Independent Monitor ENVIRONMENTAL PERFORMANCE ANNUAL REPORT 2016

McARTHUR RIVER MINE

OCTOBER 2017
Report No. 01164D_1_v2

**Independent Monitor
Environmental Performance Annual Report 2016**

FIGURE 4.7

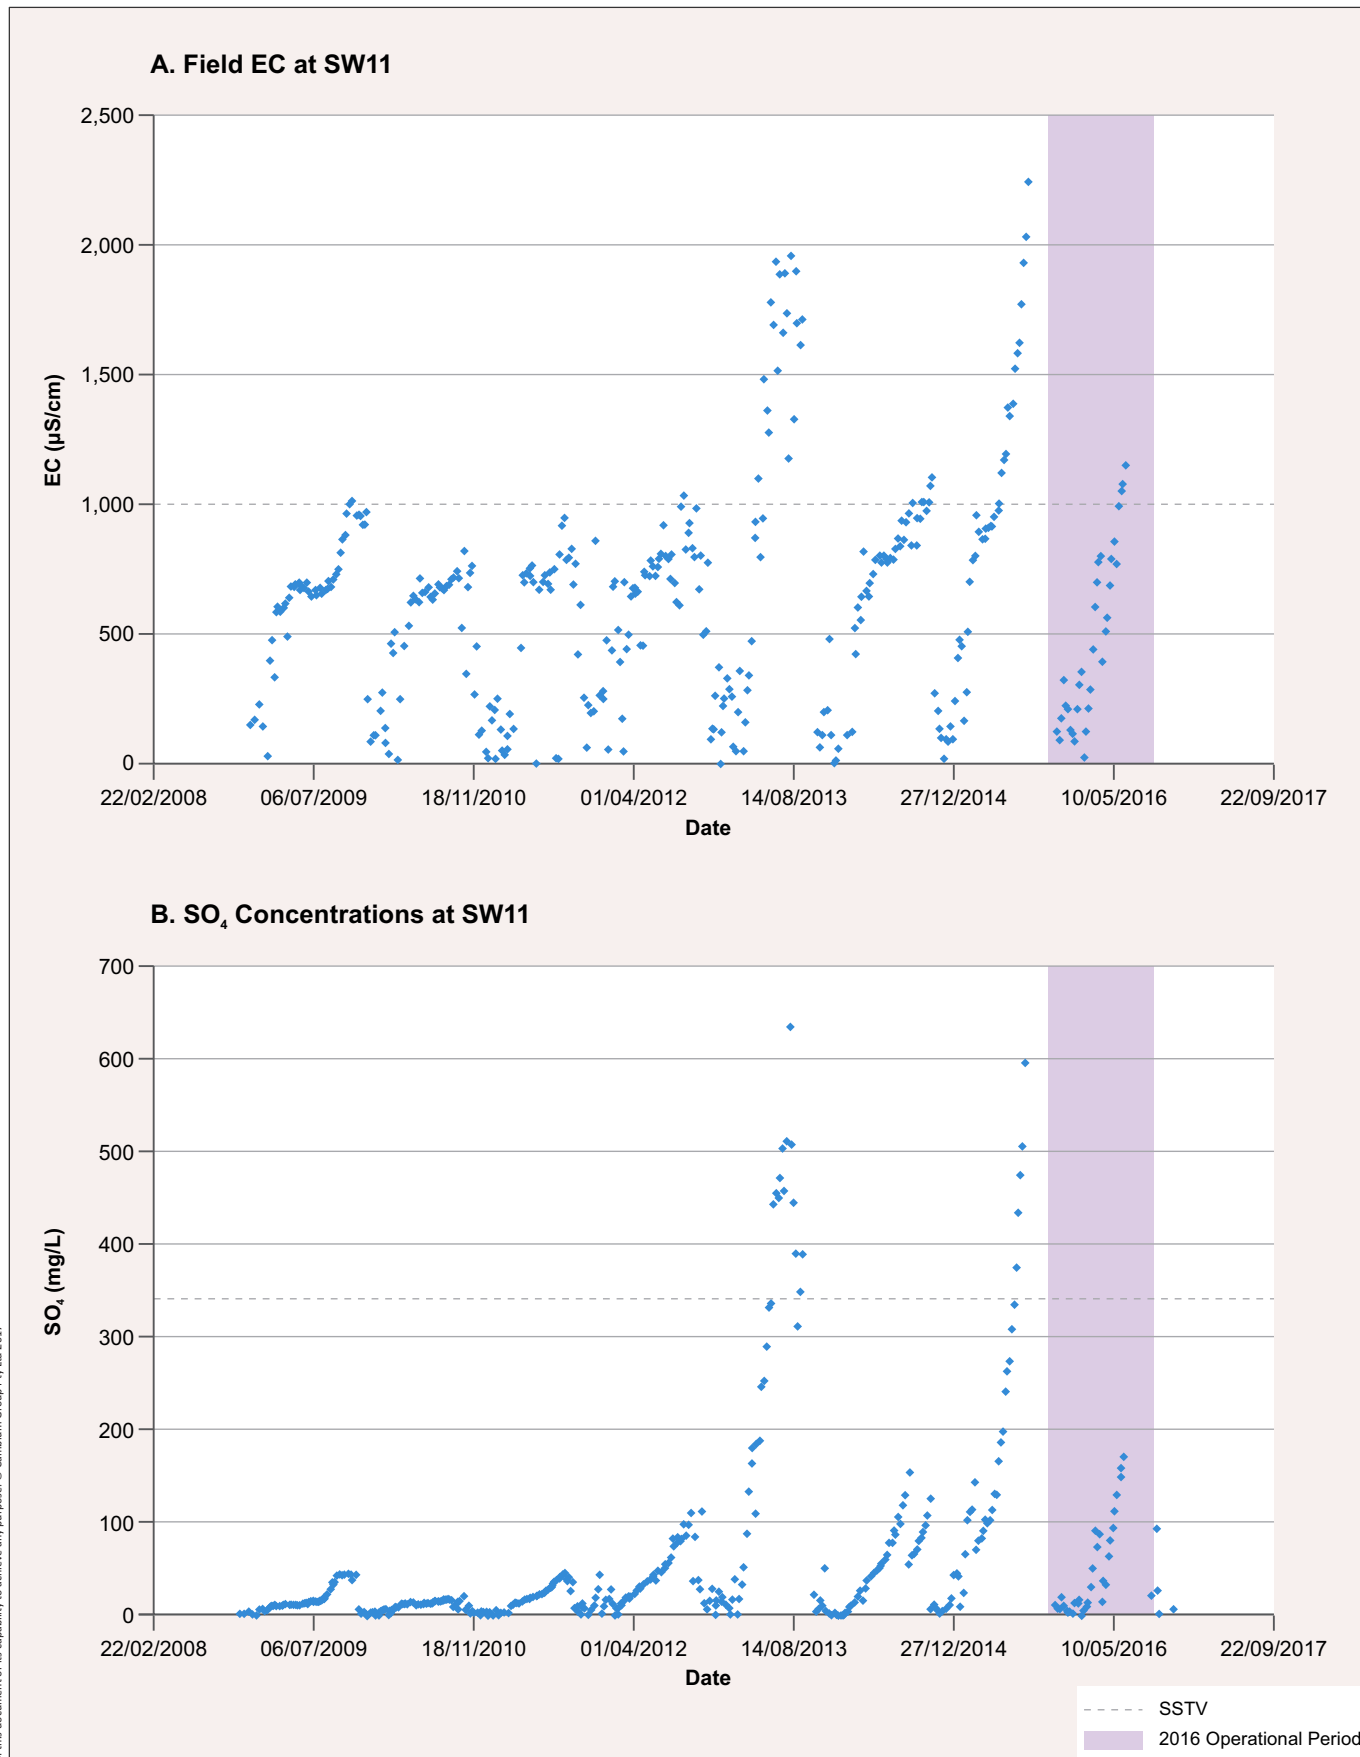
- ♦ Elevated EC values, primarily at the end of the dry season. The EC trigger value was exceeded twelve times over the 1 July 2015 to 30 June 2016 period (Figure 4.7A) – all in the period from July 2015 to September 2015, which is within the previous IM reporting period – and KCB (2016) notes the previously-reported areas of mineralisation along the McArthur River diversion channel and that 'surface water passing these exposed zones of mineralisation could be responsible for the increased EC in the McArthur River, in addition to groundwater upstream which is likely to contribute load to the system'. It is further noted that 'With the dec[r]easing flow in the diversion channel the influence of groundwater seepage on the concatenations (sic) of EC have a greater influence in water quality' (KCB, 2016), and Figure 4.8A shows the increase in EC levels that occur at SW16 and SW17. The IM notes the reference in the MRM's table of knowledge gaps to an OP ELS seepage investigation (Table 4.6), and encourages the inclusion of the OP ELS in source load calculations if appropriate, and further definition of the relative influence of groundwater inputs versus those from surface water passing through mineralised zones, with subsequent identification of mitigation measures commensurate with the risk posed by these changes in EC.

Further review of the data for the months beyond those reported in KCB (2016) shows that the elevated conductivity values that occurred in the latter months of the 2015 dry season, where a maximum of 2,240 $\mu\text{S}/\text{cm}$ on 22 September was reported before substantially decreasing (presumably due to the onset of the wet season), was repeated to a considerably lesser extent in 2016, with only the last three values recorded – 1,054, 1083 and 1,150 $\mu\text{S}/\text{cm}$ in July 2016 – exceeding the SSTV of 1,000 $\mu\text{S}/\text{cm}$ (Figure 4.7A). These

The results for SO_4 concentrations at SW11 are shown in Figure 4.7B for the period from December 2008 to December 2016, which encompasses the IM reporting period of 1 October 2015 to 30 September 2016 (as shown in the figure). During the 1 July 2015 to 30 June 2016 period, the SSTV for SO_4 at SW11 of 341 mg/L was exceeded five times, all in August and September 2015 which is within the previous IM reporting period, with the maximum value being 593 mg/L on 22 September 2015 before substantially decreasing with the onset of the wet season. Non-compliances were not apparent in the additional results for the months of July to September 2016. The elevated levels in the 2015 late dry season were attributed to inputs from the McArthur River diversion channel, as shown in Figure 4.8B for the 2014 to 2016 period, although the relative contributions of groundwater seepage versus surface water passing through mineralised rock is not known (KCB, 2016), as is the case with EC values at SW11 discussed above (and where EC is closely correlated with SO_4).

FIGURE 4.10

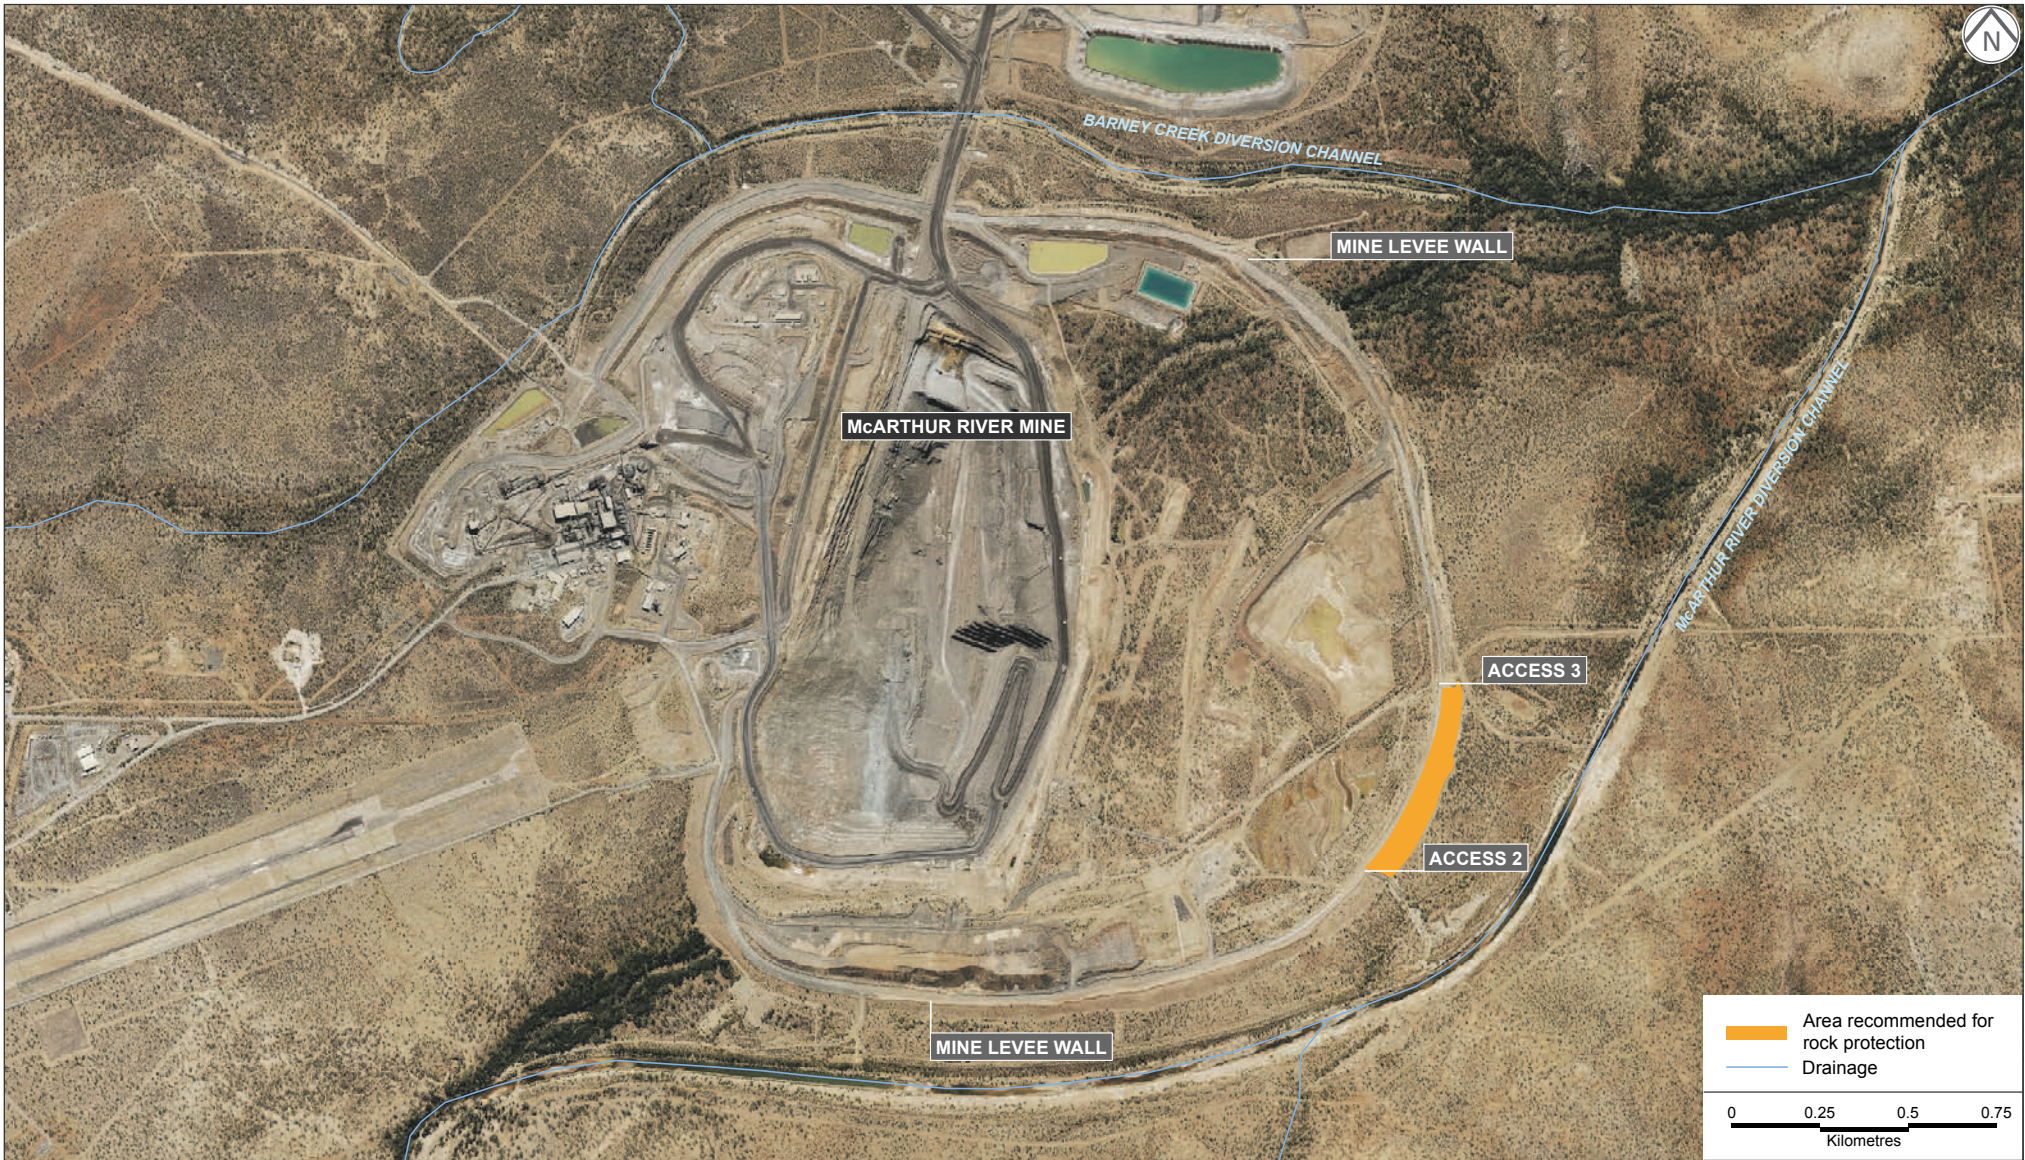
Subject	Recommendation	IM Comment
2015 Operational Period		
There were no new recommendations in the 2015 operational period		
2014 Operational Period		
Integrity of the mine levee wall	It is recommended that the mine levee wall be assessed by a qualified geotechnical engineer, particularly at the sites identified in Figure 4.7 [of the 2014 IM report]. While runoff is predicted to be minor, it is recommended that these sites be repaired to ensure stability. It is also recommended that MRM produces a plan for revegetation, stabilisation and monitoring to ensure that the levee remains intact after mine closure	<ul style="list-style-type: none"> ◆ Independent inspection undertaken (Mining One, 2016). No issue found with levee integrity; however, erosion protection of a section of the levee was recommended ◆ Geomorphic assessment undertaken in 2016 (Hydrobiology, 2016). Issues associated with an avulsion upstream of the diversion identified. A mitigation options analysis was recommended

FIGURE 4.21

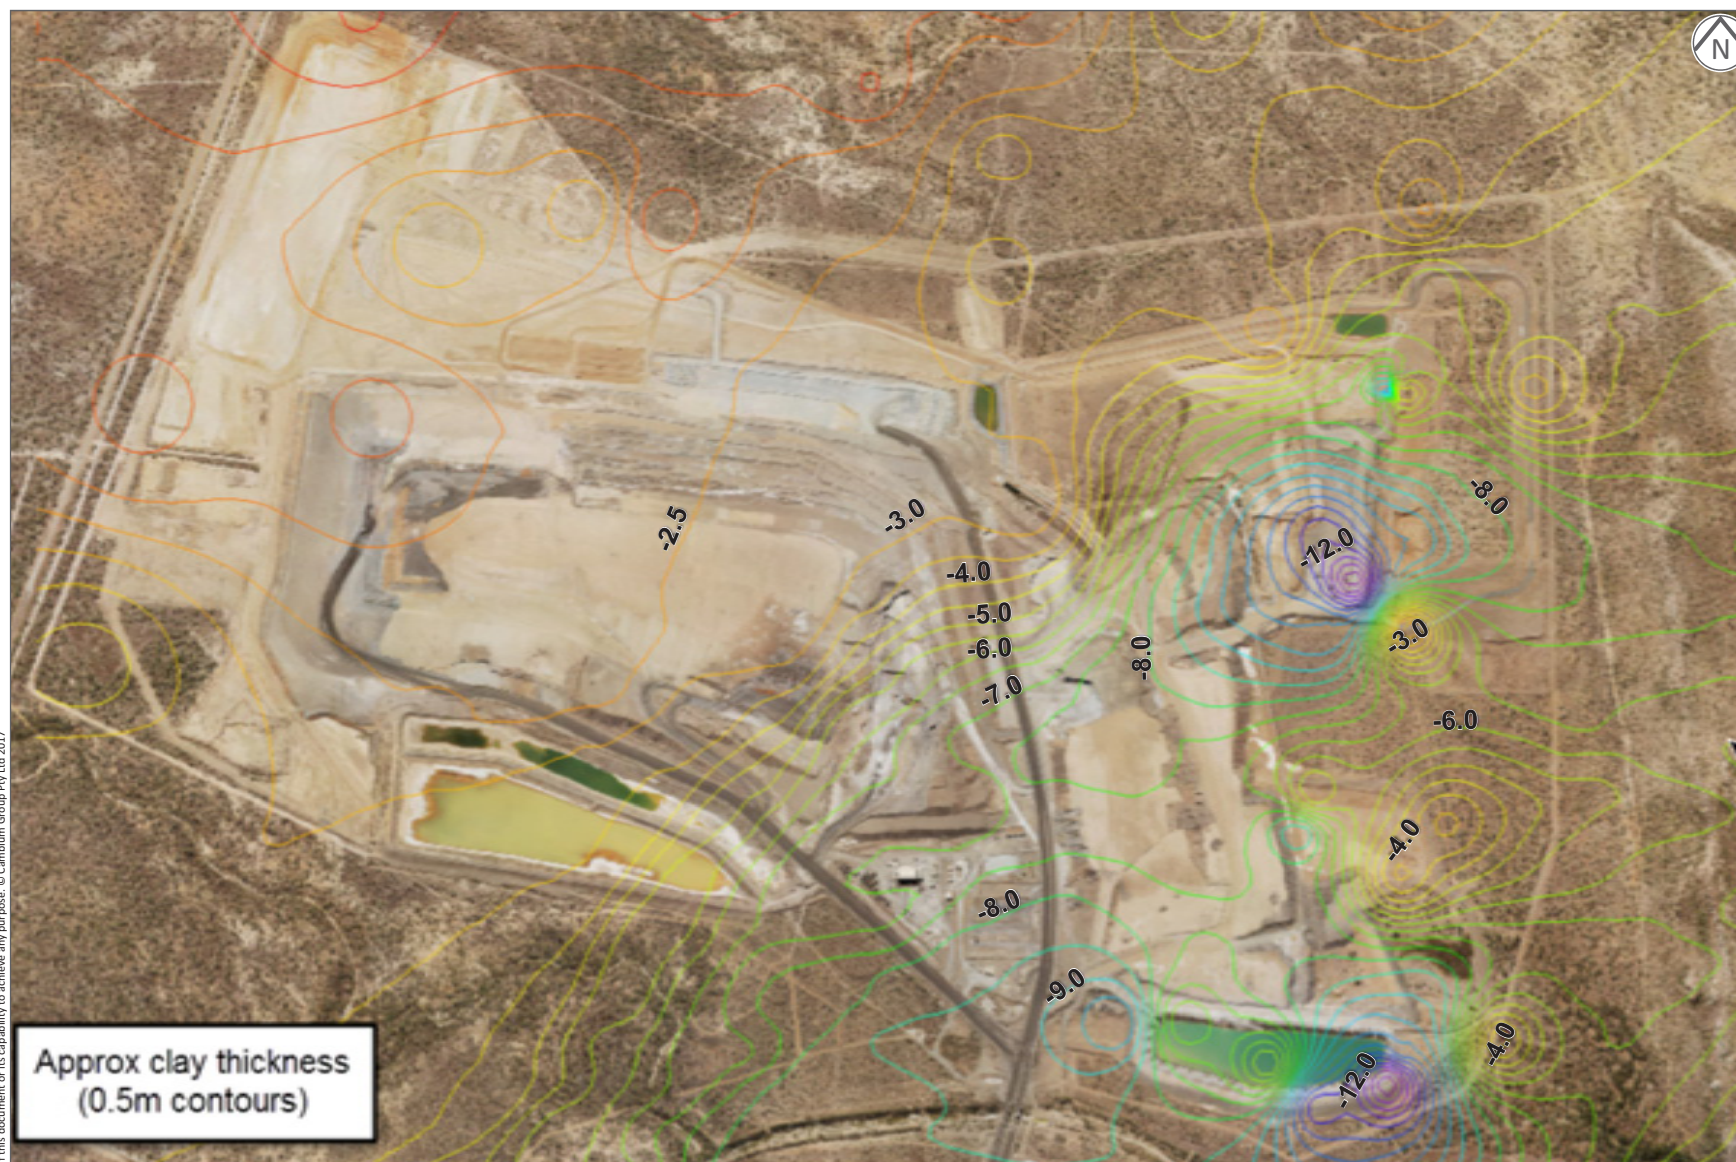
In newly-developed areas of the NOEF, the foundation layer for the NAF base layer will be compacted to direct any seepage passing through the NOEF towards an appropriate PROD. The foundations under much of the existing NOEF do not have a basal compacted layer, but do have in situ clay. Figure 4.21 is a plan showing contours of the approximate thickness of the in situ clay (i.e., clay suitable for construction, not the entire thickness of alluvium) at the base of the NOEF. It is understood that very little clay was excavated from the NOEF footprint, as clay was used from the pit clearing areas during this timeframe. The figure indicates that even where active compaction was not carried out in the West and East stages, the in situ clays have a thickness ranging from 1.5 m in the west to 12 m in the east. McArthur River Mining personnel expressed the opinion during the site visit that any seepage from the NOEF will tend to drain along the clay layer and is likely to mainly report to surrounding PRODs. While the presence of relatively thick in situ clay appears to support this, further investigation would be required for confirmation. Figure 8-11 of the Draft OMP EIS (MRM, 2017a) shows clear evidence of high SO_4 concentrations in groundwater below the footprint of the NOEF, and elevated EC (primarily controlled by SO_4) continues to be reported from Surprise Creek and Barney Creek (KCB, 2016b). Much of this could be from previous contributions from the NOEF SPROD and NOEF SPSPD when they were inadequately lined (both now have a better-constructed compacted clay lining), but the contribution from NOEF direct seepage is uncertain.

FIGURE 4.22

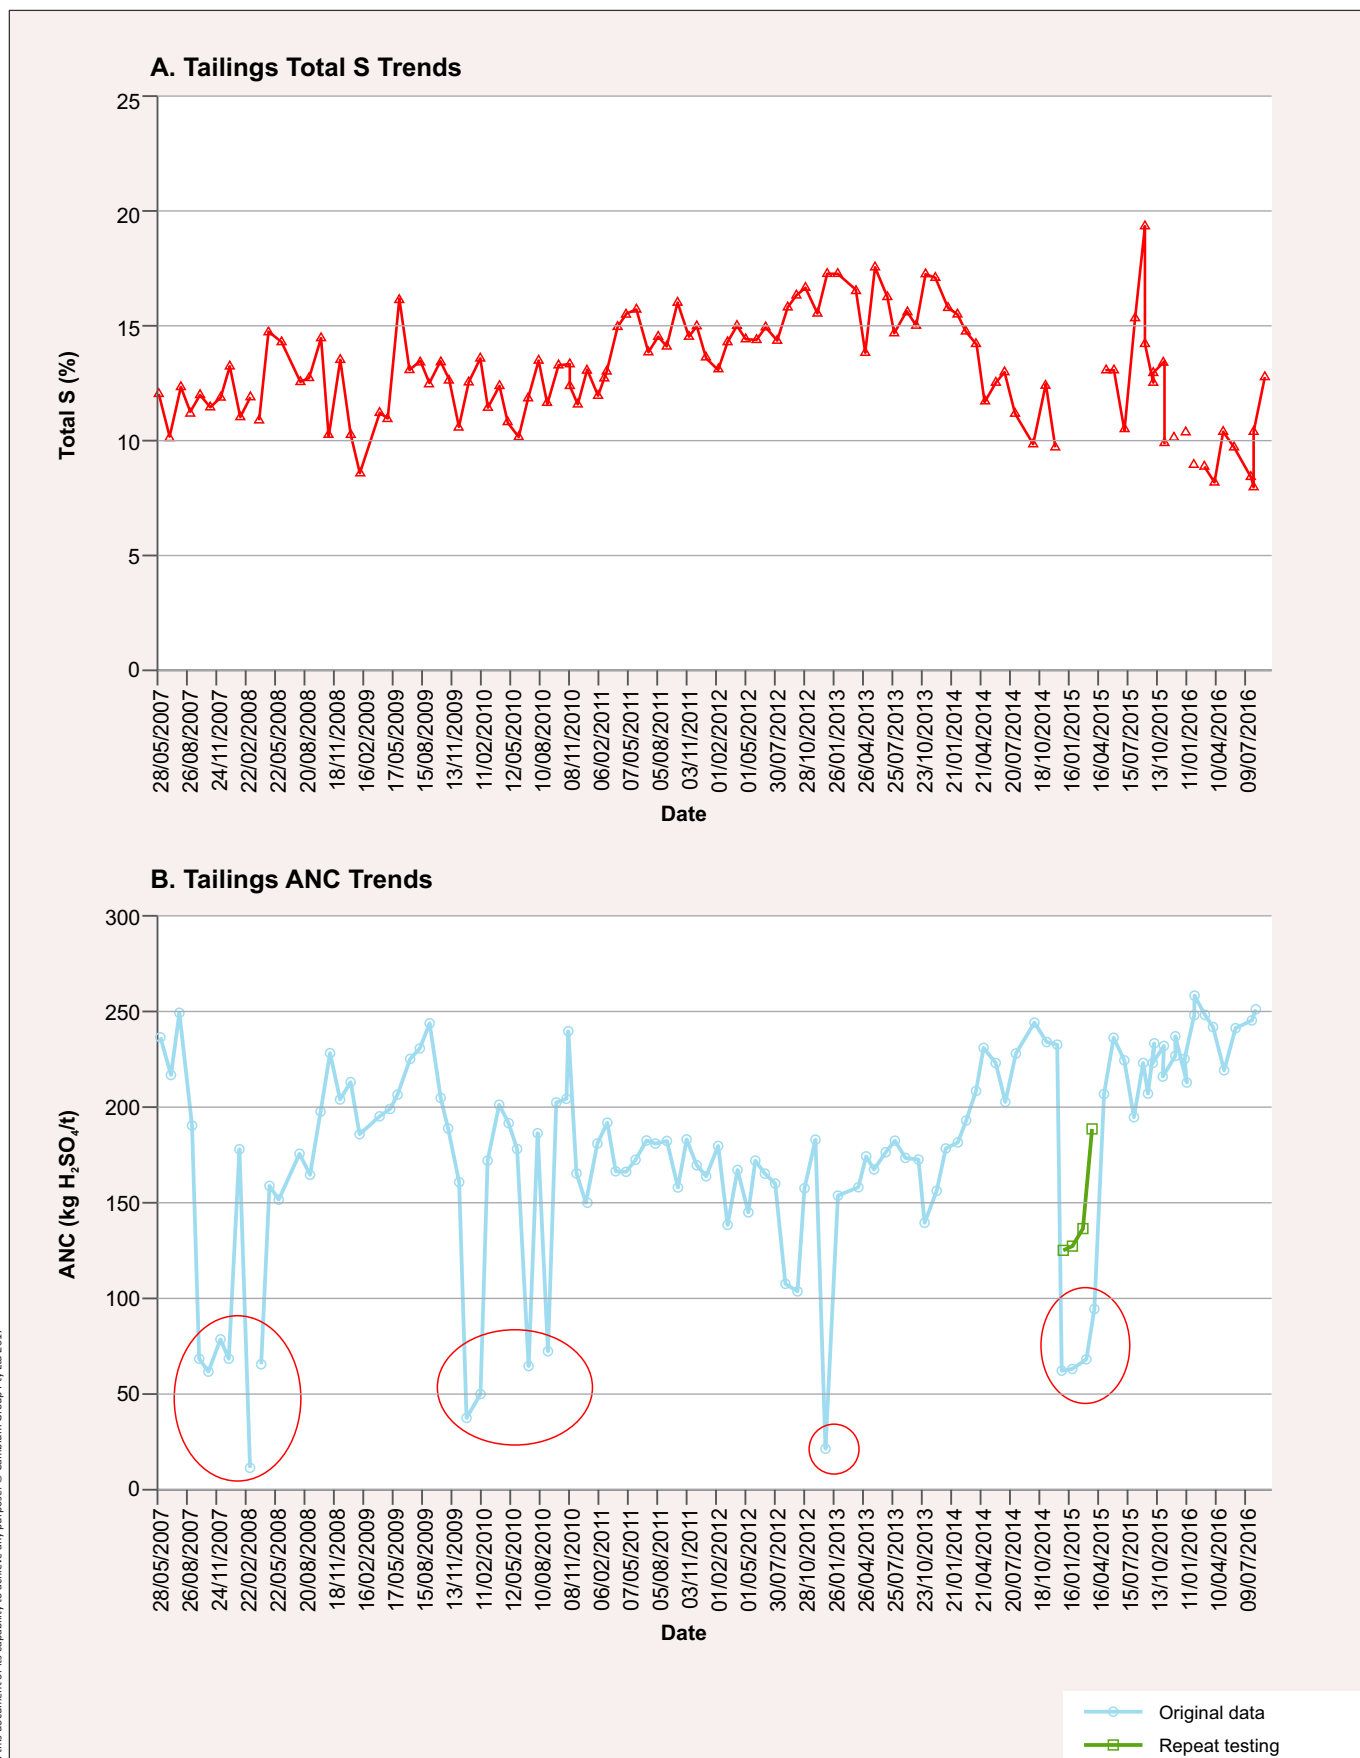
Tailings S and ANC results from May 2007 to August 2016 are shown in Figure 4.22. Results from the current IM review period are consistent with those previously reviewed, with the tailings expected to be PAF with very high acid generating capacity, but generally with high ANC, and a lag would be expected before acid conditions develop after exposure to atmospheric oxidation conditions. Total sulfur contents are also similar to previous results and very high relative to typical base metal mine tailings, varying from approximately 10 to 18%S.

The ANC data in Figure 4.22B continues to show the vast bulk of the tailings samples have high ANC values greater than 150 kg H₂SO₄/t. In the 2015 IM report, it was noted that the ANC results for tailings collected in December 2014 to March 2015 showed lower ANC values than expected, ranging from 60 to 95 kg H₂SO₄/t compared to median values of approximately 180 kg H₂SO₄/t. Repeat testing indicated the anomalous values were related to laboratory issues, and continued testing demonstrates that these low values were anomalous.
